REPORT CORRECTED BY STAFF 1/12/89
CITY PLANNING COMMISSION

APPLICANT BRANT CONSTRUCTION MANAGEMENT, INC. 2001 N. Cline Ave., Griffith IN 46319
OWNER I-80 INDUSTRIAL ASSOCIATES, 1455 Response Rd. #290, Sacramento, CA 95815
PLANS BY Brant Construction Management, Inc. 2001 N. Cline Ave. Griffith, IN 46319
FILING DATE 10/20/88 **ENVIR. DET. Neg. Dec.** 12/29/88 **REPORT BY** JP:vf
ASSESSOR'S PCL. NO. 238-0220-007

- APPLICATION:**
- A. Negative Declaration
 - B. Variance to waive the City's standard surfacing requirement for a portion of the storage, service and sales area for a proposed construction equipment sales and service facility.
 - C. Plan Review for a 35,282+ square foot construction equipment sales and service facility on 7.7+ acres in the M-1S-R zone.

PROPOSAL: The applicant is requesting the necessary entitlements to construct a 35,282+ square foot construction equipment sales and service facility (J. I. Case Company) in the area known as the I-80 Industrial Park

EXHIBIT A SITE PLAN

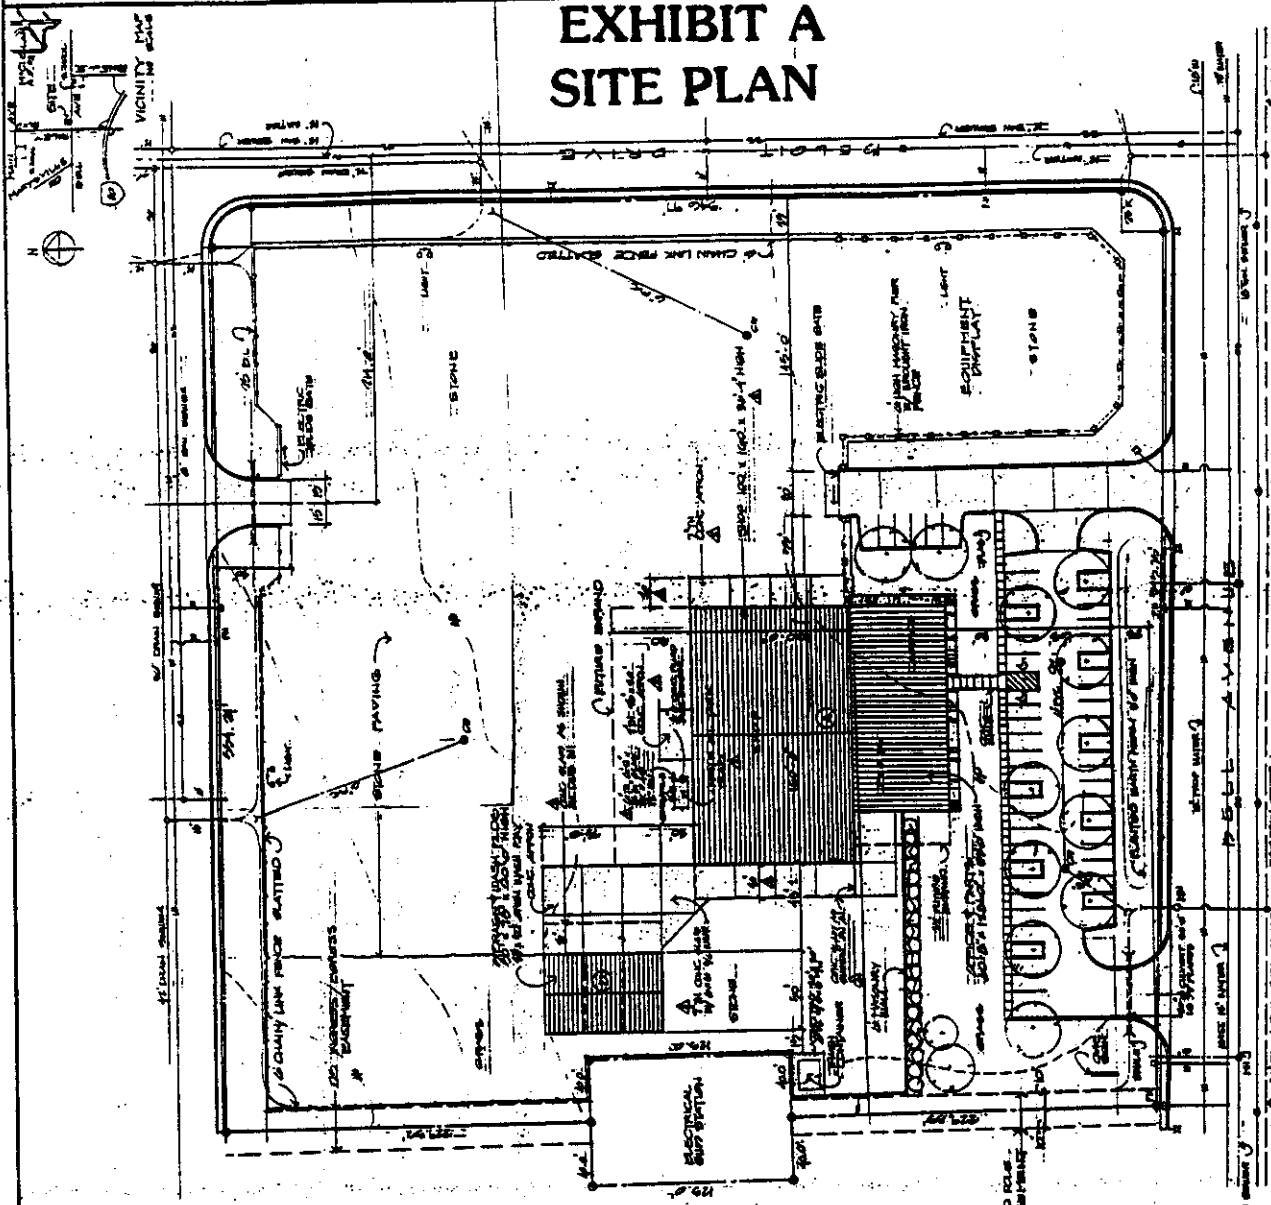
The applicant has not submitted a landscape plan as part of the proposal. Some landscaping has been indicated on the site plan such as a three foot high berm along a portion of the Bell Avenue street frontage, trees to meet the parking lot shading requirement, grass in front of the main building and shrubs adjacent to the masonry wall. Planning staff finds that since the site has three public street frontages landscaping is an important element of the site plan design. Staff, therefore, recommends the following items be incorporated in the landscape plan for the project:

The applicant has indicated three fencing types on the submitted site plan: a six foot high masonry wall located to the west of the main structure and parallel to Bell Avenue; a six foot high wrought iron fence around the equipment display area; and a six foot high chain link fence with either wood or vinyl slats around the perimeter of the equipment storage area. Staff recommends that vinyl rather than wood slats be used in the chain link fence; as vinyl slats will hold up better over time. Staff also recommends that the masonry wall incorporate a decorative element.

Forty eight (48) parking spaces are indicated on the submitted site plan. Staff has determined that there are three main components to the proposed case company operation, an office component (5,338 square feet); a commercial component (10,194 square feet); and a warehouse/industrial component (19,750 square feet). Using the parking ratios required for office, commercial and industrial uses Planning staff has determined that 53 parking spaces are required. The site plan will need to be revised to accommodate these five additional spaces. One loading/unloading space and bicycle spaces will also be required for the proposed use.

The applicant has indicated two signs to identify the Case facility: a 113+ square foot attached sign painted to the south side of the building and a 135+ square foot, 30+ foot high detached pole sign. Planning staff recommends that the pole sign be replaced with a detached monument sign. Staff finds that a monument sign would be more aesthetically pleasing and be compatible with the Sacramento Security Park complex on the south side of Bell Avenue which also prohibits pole signs.

2. A revised landscape, shading and irrigation plan shall be submitted and subject to Planning staff review and approval prior to issuance of building permits. This plan shall indicate:

3. The masonry wall located to the west of the main structure shall incorporate a decorative element and the design and materials of the wall shall be subject to Planning staff review and approval prior to issuance of building permits.

4. The proposed chainlink fence located around the perimeter of the equipment storage area shall utilize vinyl slats as a screening device.
5. The submitted site plan shall be revised to indicate 53 vehicle parking spaces, one loading/unloading space and the location of the required bicycle spaces.

7. All detached signs located on the site shall be monument signs with a maximum height of eight feet. The design and materials of any proposed monument sign shall be subject to Planning staff review and approval prior to issuance of a sign permit.

REVISED BY STAFF 1/12/89 **EXHIBIT B**
STAFF EXHIBIT

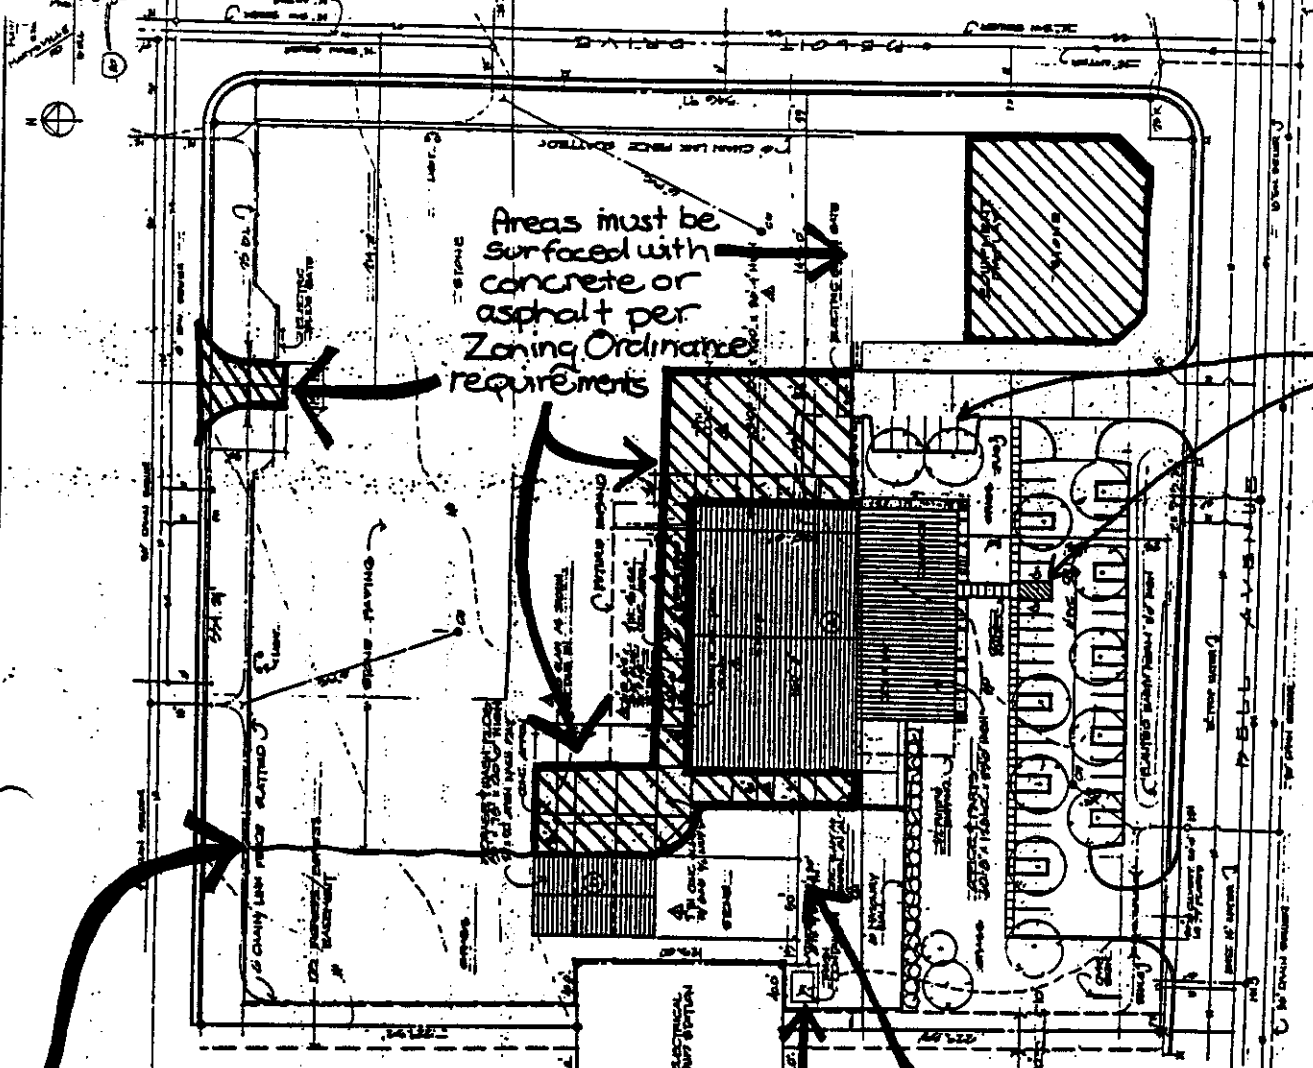
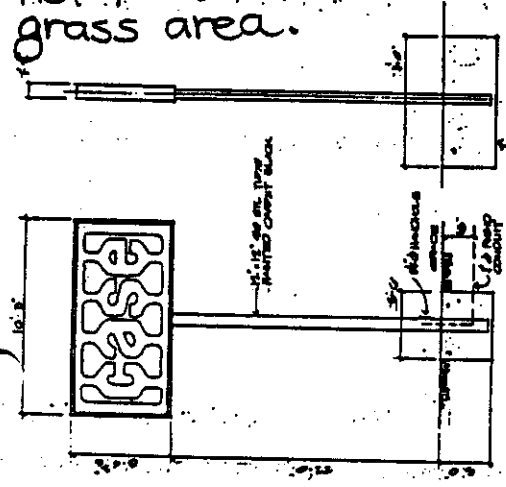
Areas must be surfaced with concrete or asphalt per Zoning Ordinance requirements

Parking lot to meet City Surfacing and Landshading requirements

Solid barrier required between stone and grass area. Storage not permitted in grass area.

Trash enclosure to meet Zoning Ordinance Surfacing requirements

Area must meet City Surfacing requirements if used for vehicle repair

6. All equipment repair areas, the parking lot on the southern portion of the site, all driveways, areas surrounding the two buildings located on the subject site and the equipment display area shall be surfaced in accordance with City standards (see Exhibit B). Equipment storage areas may be surfaced with rock or crushed stone. Any grass areas shall be barricaded from vehicle storage areas. Drainage for the vehicle storage areas must comply with the requirements of the City Public Works Department, the Fire Department and the City/County Health Department. The applicant shall revise the site plan to indicate those areas that will be surfaced in accordance with City requirements and those areas to be surfaced with rock or gravel subject to Planning staff review and approval prior to issuance of building permits.

EXHIBIT E ELEVATIONS

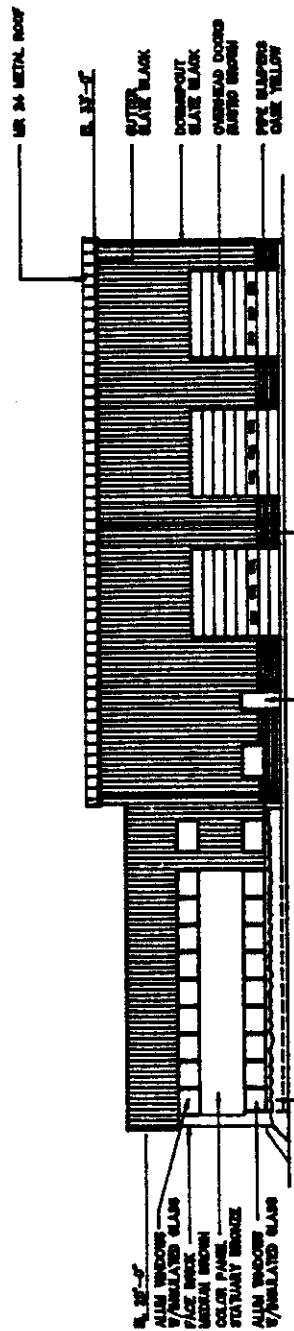
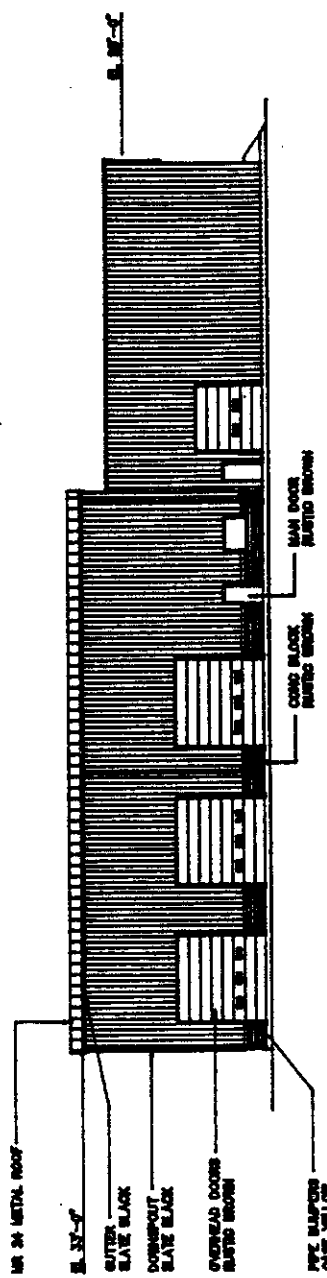
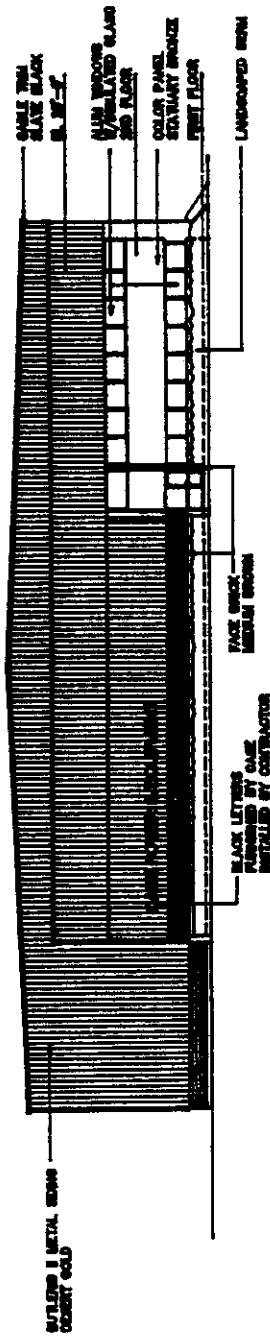
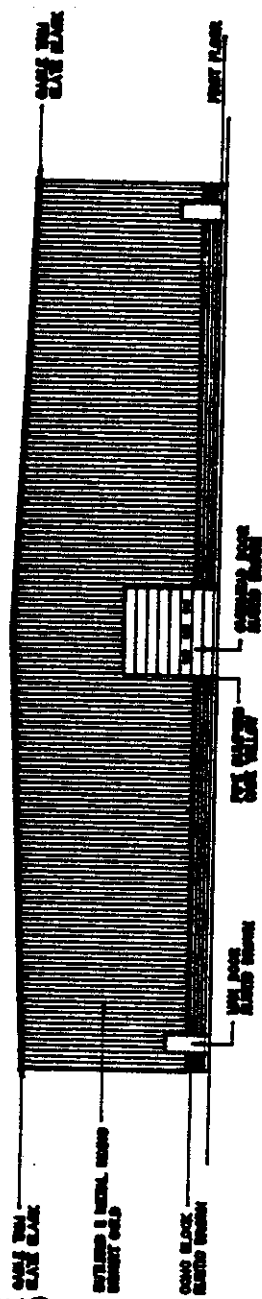
The applicant proposes that the two buildings on the site be constructed out of metal. Proposed colors are desert gold with brown and black trim. Planning staff finds that the front of the building which faces Bell Avenue should have some additional detailing to provide visual interest to this facade. This could be accomplished through the use of architectural projections or third dimensional design changes to the facade. Brick or tile could also be used as accent materials. Additional landscaping at the building entrance could also enhance the structure. Staff recommends that the applicant revise the south and east building elevations to include a decorative element(s) subject to Planning staff review and approval.

1. The applicant shall revise the submitted building elevations for the 31,532⁺ square foot main building to add a decorative element to the south and east facades of the building. The revised elevations shall be subject to Planning staff review and approval prior to issuance of building permits;
